Product Bulletin

Commercial Availability & G-70-52-AM Clarification

Commercial Availability & G-70-52-AM Clarification

ENHANCED VAPOR RECOVERY (EVR)-CERTIFIED REPLACEMENT PARTS FOR ORVR-COMPATIBLE BALANCE VAPOR RECOVERY SYSTEMS

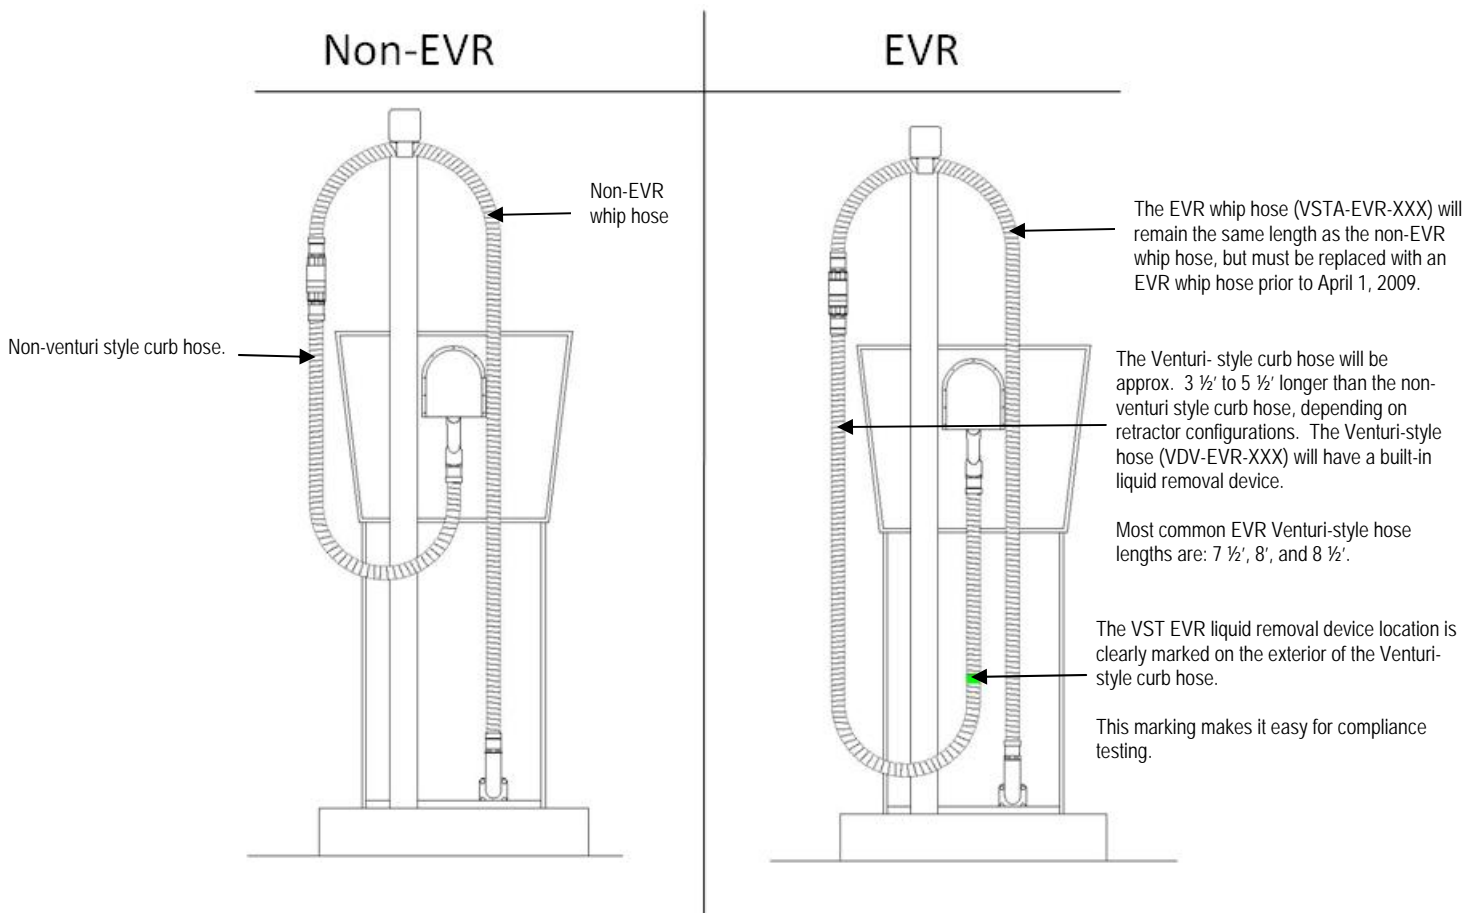
The purpose of this bulletin is to clarify G-70-52-AM and Commercial Availability to explain the correct EVR hanging hardware requirements and hose configuration when replacing a non-EVR hose with an EVR-approved curb hose. CARB's Commercial Availability Advisory 374 (see attached) becomes effective on November 1, 2008, requiring GDF owner / operators to begin replacing non-EVR hanging hardware with EVR-approved hanging hardware.

1. EVR-approved curb hoses must be a Venturi style, meaning they contain built-in liquid-removal devices.
 - VST is the only provider of Balance, EVR-approved, Venturi-style curb hoses for VST EVR systems.
2. Venturi hoses will be 3 ½' to 5 ½' longer than the existing non-EVR curb hose to allow the Venturi hose to function properly.
3. The whip hose will remain the same length.
4. If you intend to install a VST EVR balance system, below is an example of a proper hose geometry conversion.
